EVERSTEAD
SHOP DRAWINGS/SUBMITTAL REVIEW

JOB No.	3008832
DESCRIPTION	Clover & Hive - 156 Cobey Creek
JOB ADDRESS	3534 SE Corbin Dr
CITY	Lee's Summit, MO
DESIGNER	Scott Clevenger
DATE	12/14/2021

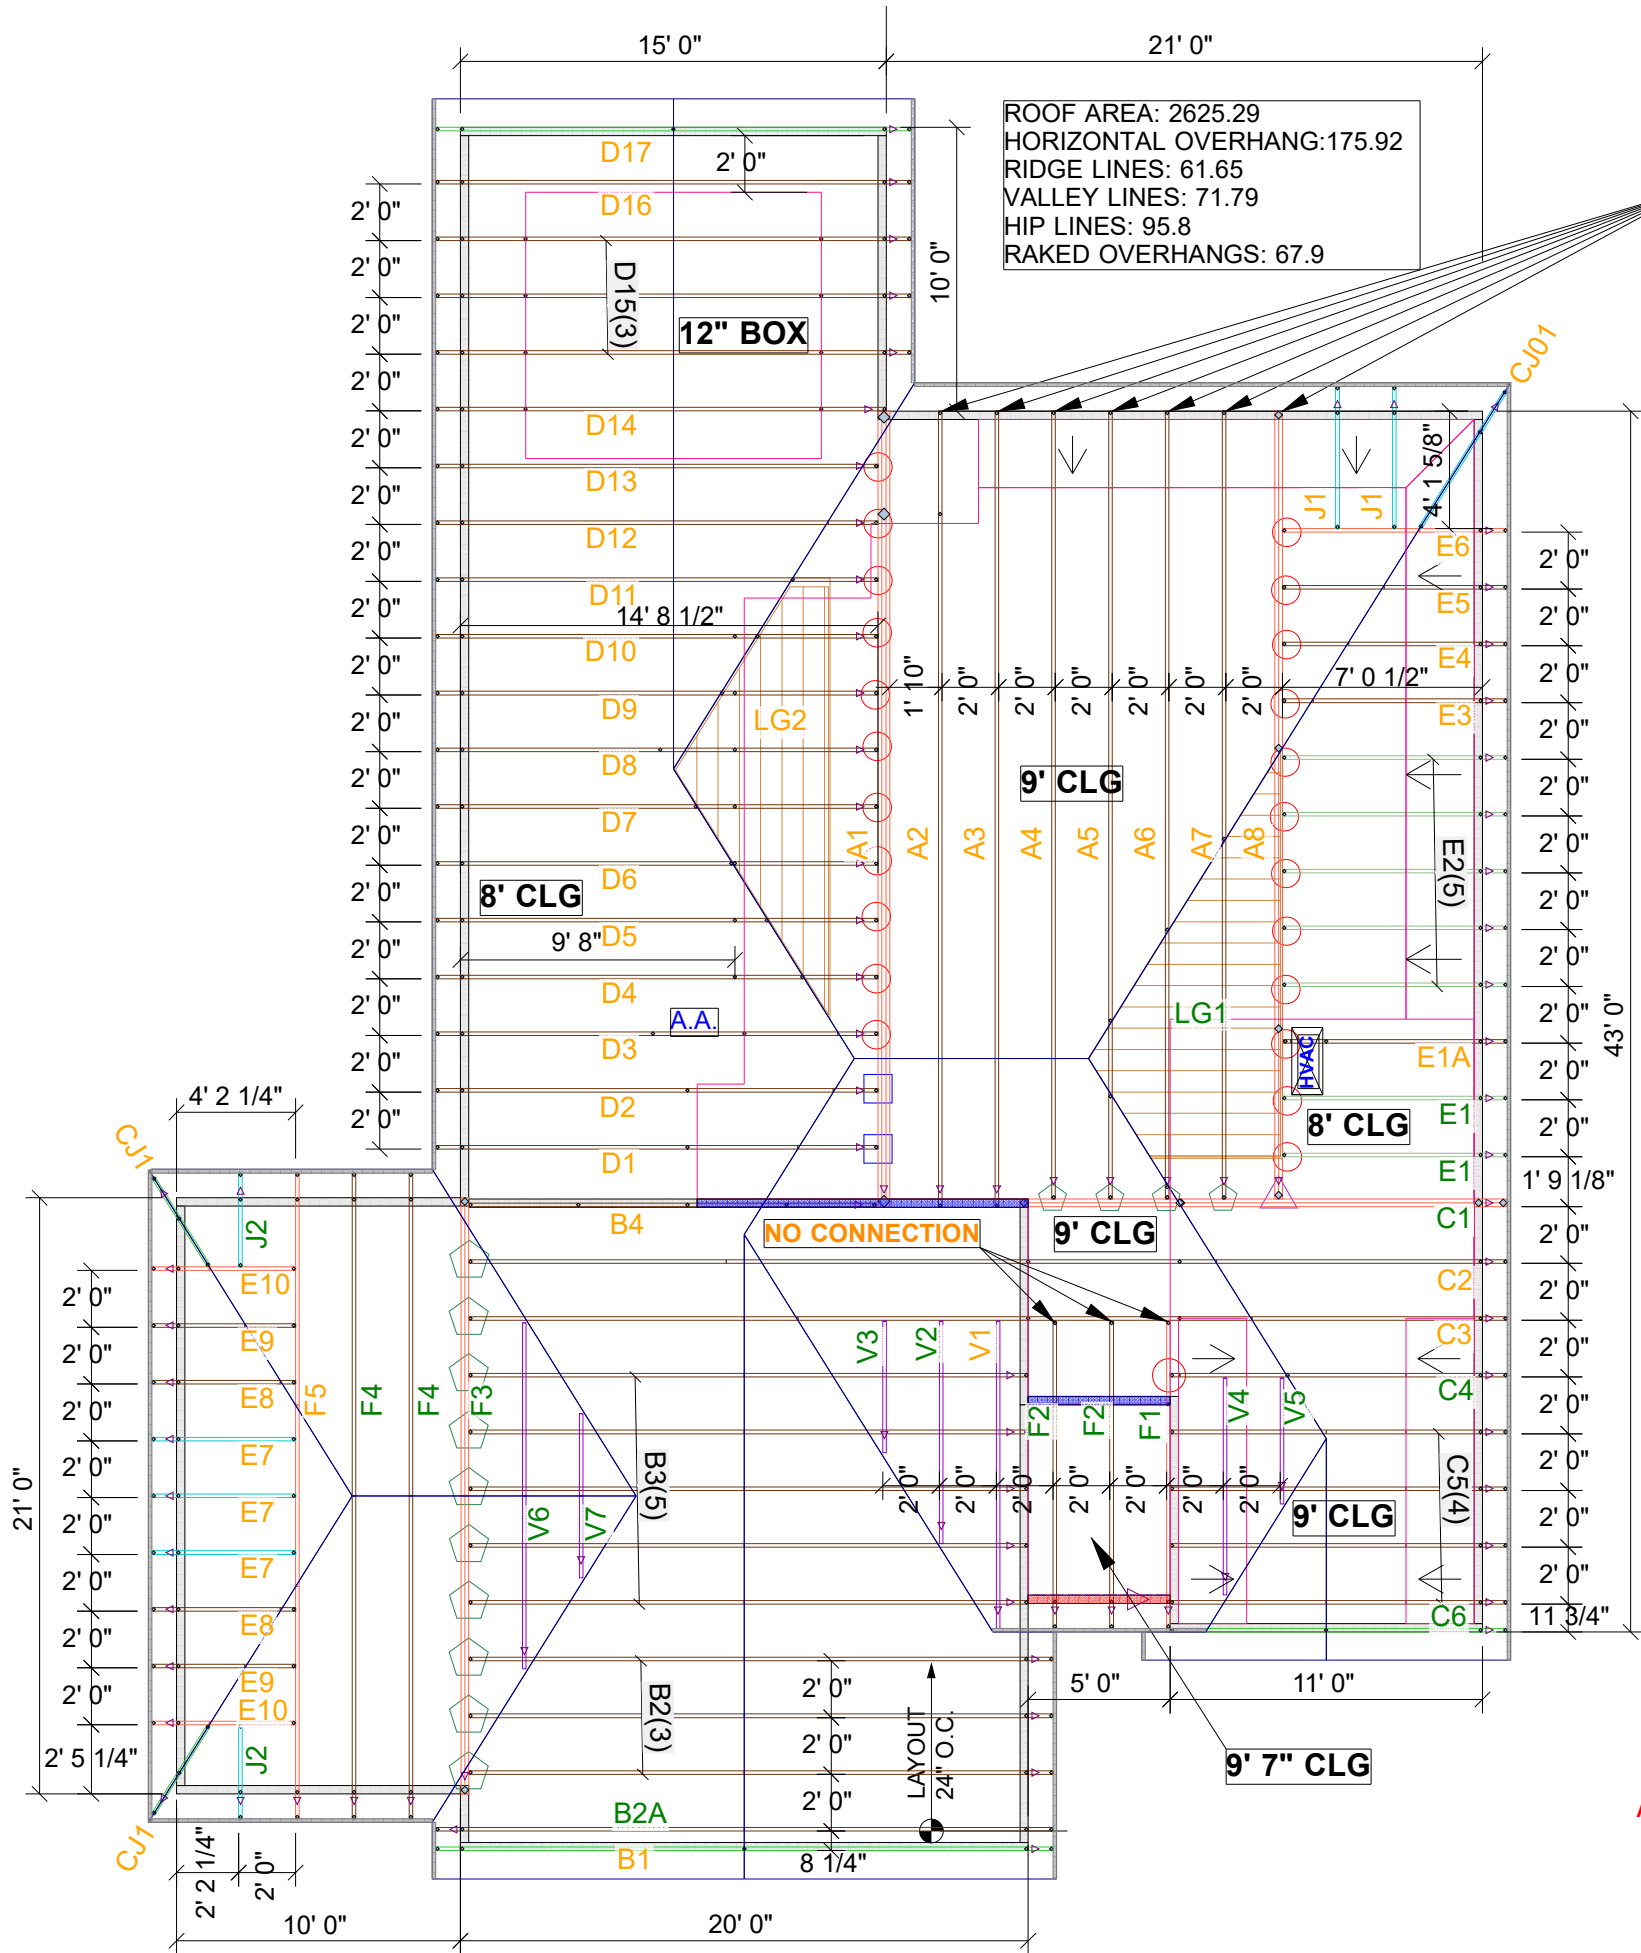
STATUS :

APPROVED

01/06/2022
